City of Surrey PLANNING & DEVELOPMENT REPORT Application No.: 7920-0284-00

Planning Report Date: March 7, 2022

Response to ADP Comments 20-0284-00 December 16, 2021 ADP Meeting

LEVEL 8 AMENITY

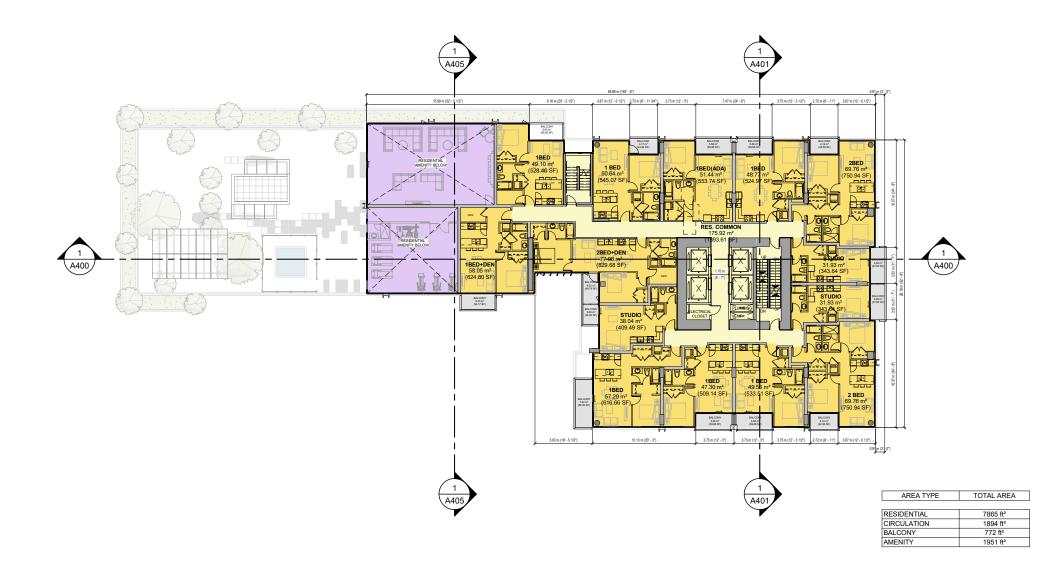
- Consider more direct connectivity between interior circulation/spaces to the Level 8 outdoor amenities. A direct access to the outdoor amenity has been provided.
 Please see sheet A213.

- Recommend providing access to the amenity space without passing through fitness area in the central level. A direct access to the outdoor amenity has been provided.
 Please see sheet A213.

- Consider providing some amenity space geared to more active use, such as adjacent
 the level 8 gym, where a space given over to outdoor stretching, exercise, would be
 appropriate. Active amenity was added to level 8 with the addition of a yoga,
 stretchy area, a canopy for the large gathering area and sinks added to the outdoor
 kitchen areas.
